**Amendments to the Drawings:**

**REMARKS**

Atty. Dkt. No. 027478-0113

## APPENDIX A

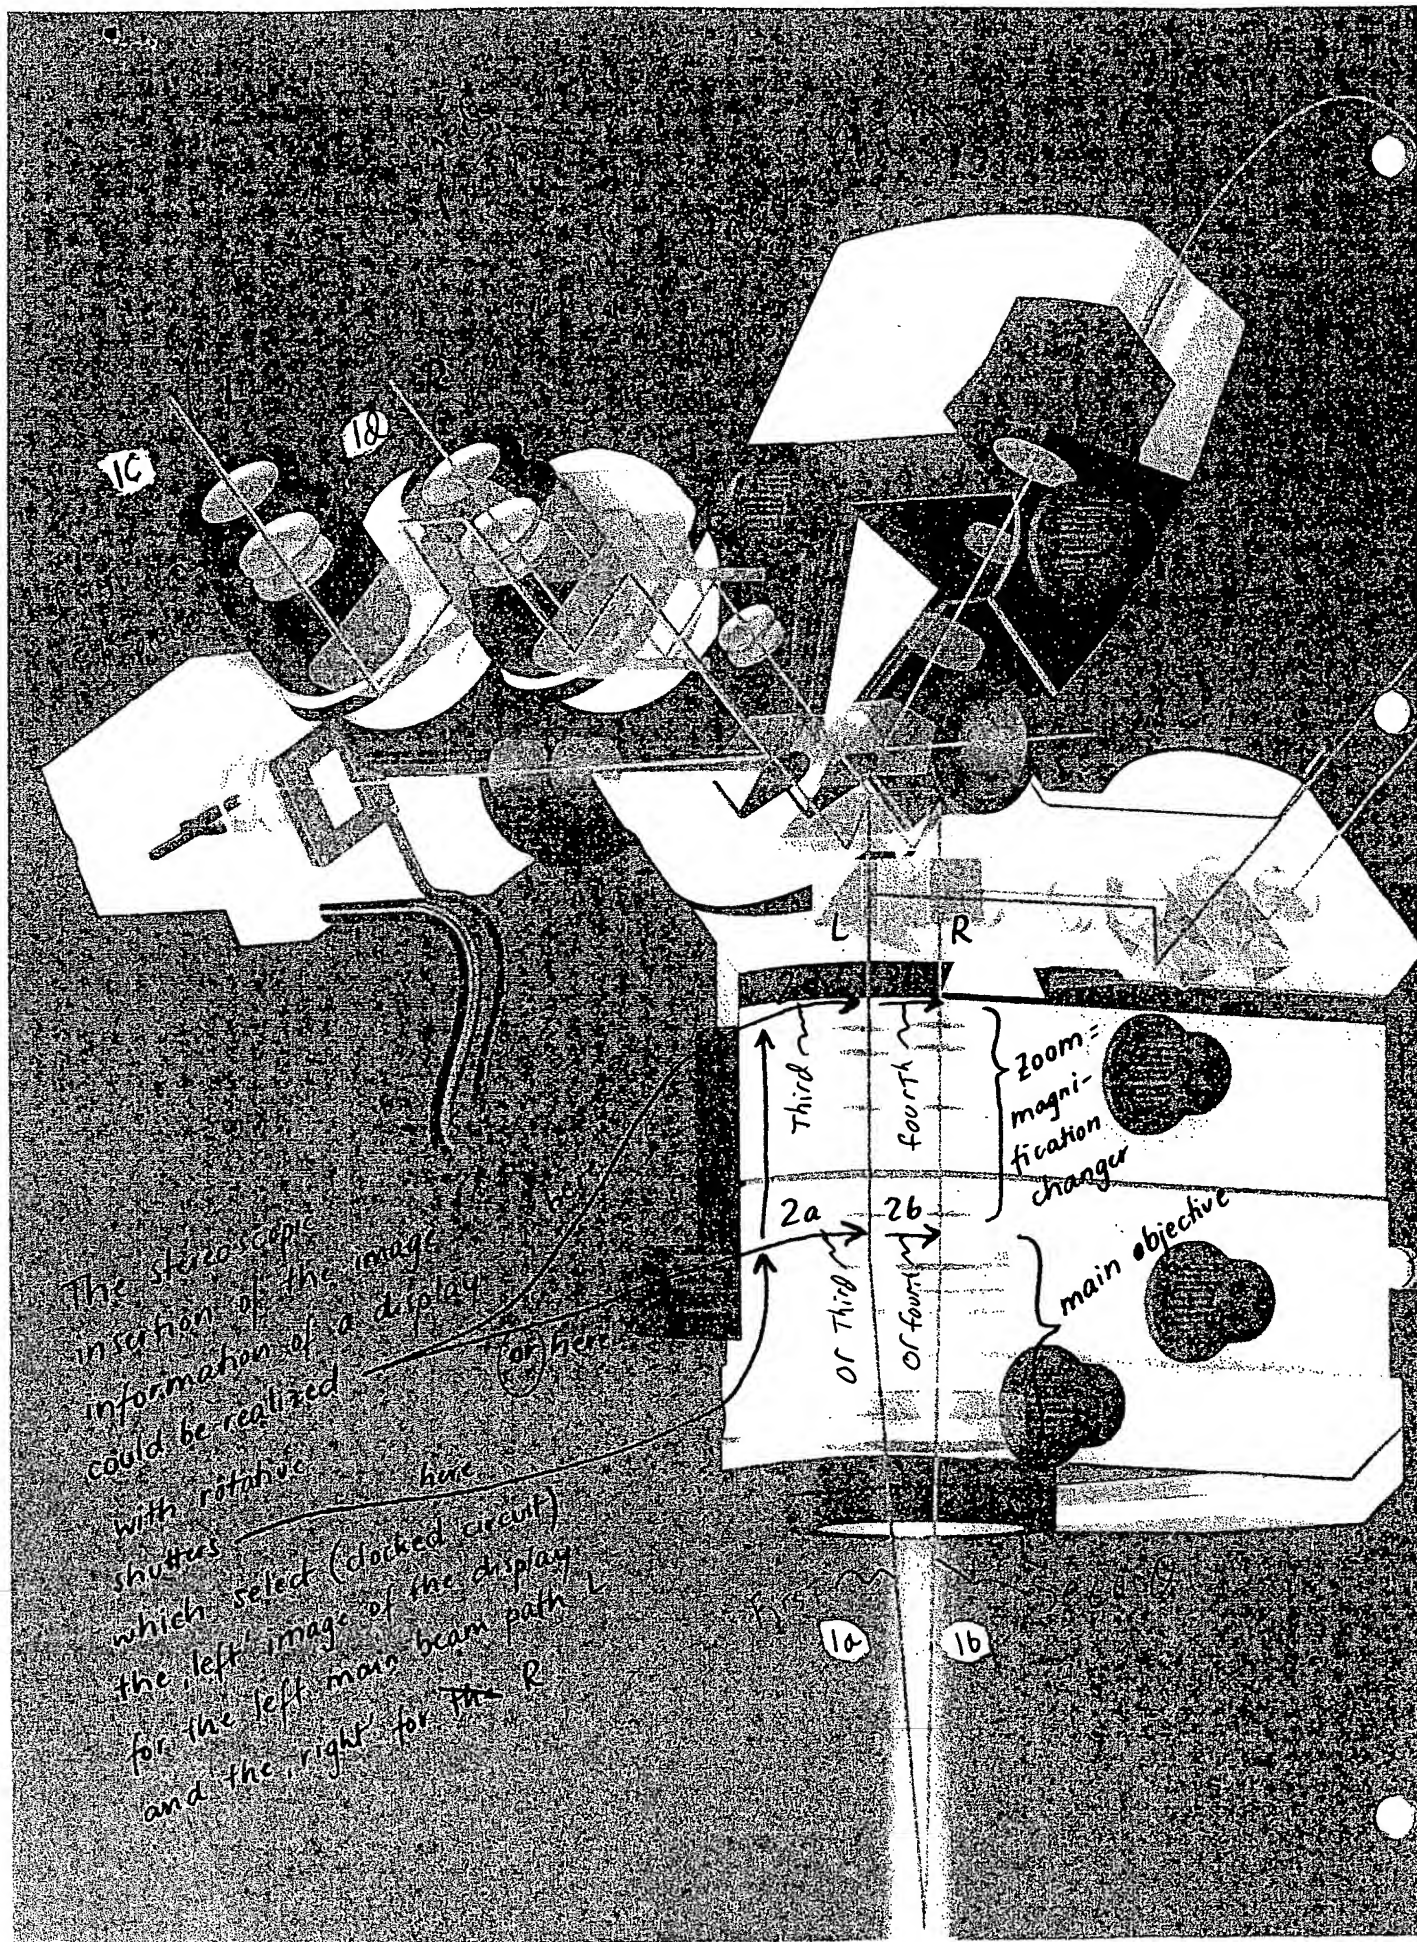
The attached drawing sheets containing Figures 2 and 15 are being presented as new formal drawing sheets to be substituted for the previously submitted drawing sheets. Figure 2 and Figure 15 have been amended.

In Fig. 2, reference number "2L" has been changed to "19."

In Fig. 15, the reference number "10a" has been changed to "9 / 10a."

In regard to claims 4-5, 21-22 and 31-32, Applicants have amended Fig. 15 to replace the reference number “10a” with “9 / 10a,” and respectfully point to paragraph 0099 of the published application, which states that, in reference to Fig. 15, this “construction - and also that of Fig. 18 - could be equipped with an image recording device instead of the display 10a.” Reconsideration is respectfully requested.
